DETERMINATION ON REMAND
AND
SUPPLEMENTAL COMPARATIVE ANALYSES OF REMEDIAL ALTERNATIVES
FOR THE GENERAL ELECTRIC (GE)-PITTSFIELD/HOUSATONIC RIVER SITE
REST OF RIVER

EPA REGION 1

JULY 2020

EA 10a

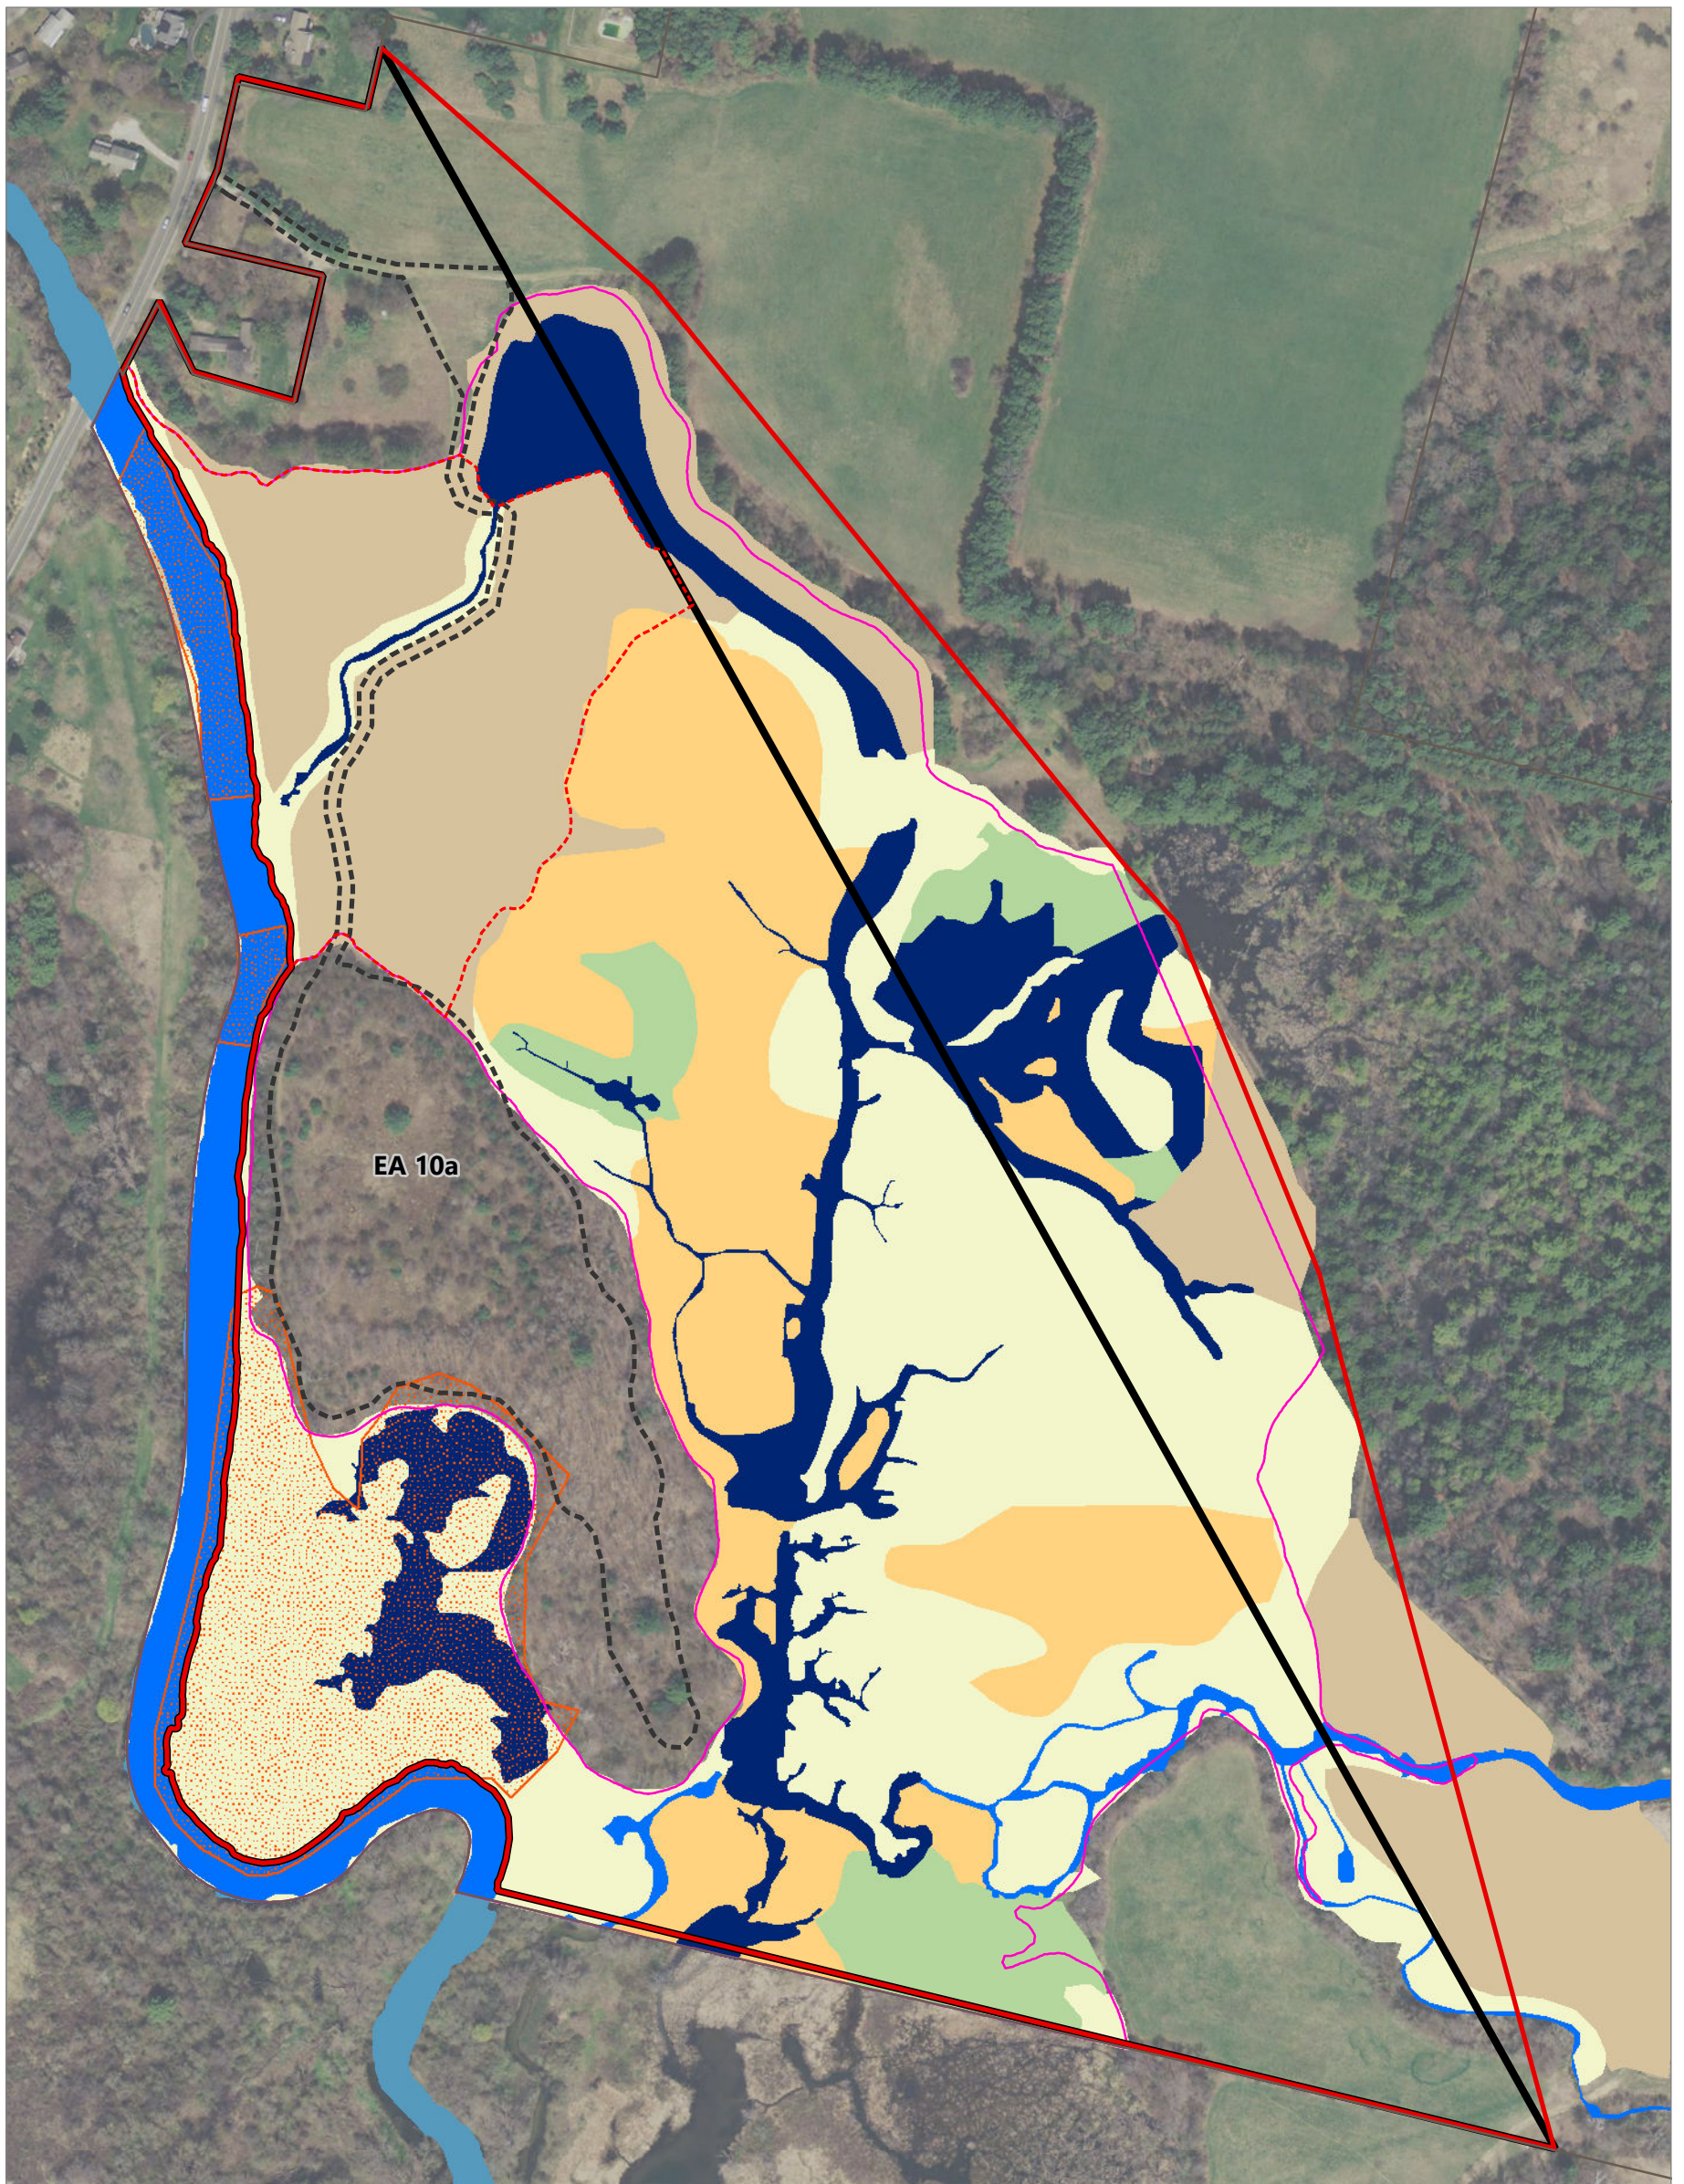
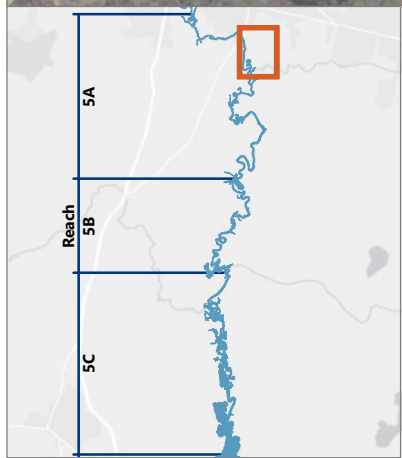
- c) For the Mass Audubon Canoe Meadows Property, GE will expand the Exposure Area ("EA") 10 boundary to the east so that the EA incorporates the area with PCBs greater than 1 ppm in the top foot of soil and include an additional subarea, beyond that included in the 2016 Permit, as shown in Figure 6 of the Settlement Agreement.

1. Expand the Exposure Area (EA) 10 boundary to the east so that the EA incorporates the area with PCBs greater than 1 ppm in the top foot of soil. This expansion would also allow evaluation of the trail in this area. The expanded EA is shown in Figure 6.
2. Include an additional subarea, beyond that included in the 2016 Permit, in the attached Figure 6 Mass Audubon Property Revised EA 10 Remediation and remediate additional floodplain soils to meet the applicable floodplain soil Performance Standards.

In the Draft Revised 2020 Permit, the additional cleanup activities at the Canoe Meadows property are incorporated in Section II.B.3. and Table 1, and are shown in attached Figure 3A - Exposure Area 10. The revised requirements for the Reaches 5A and 5C Floodplain are incorporated into the Draft Revised 2020 Permit at Section II.B.3.a.
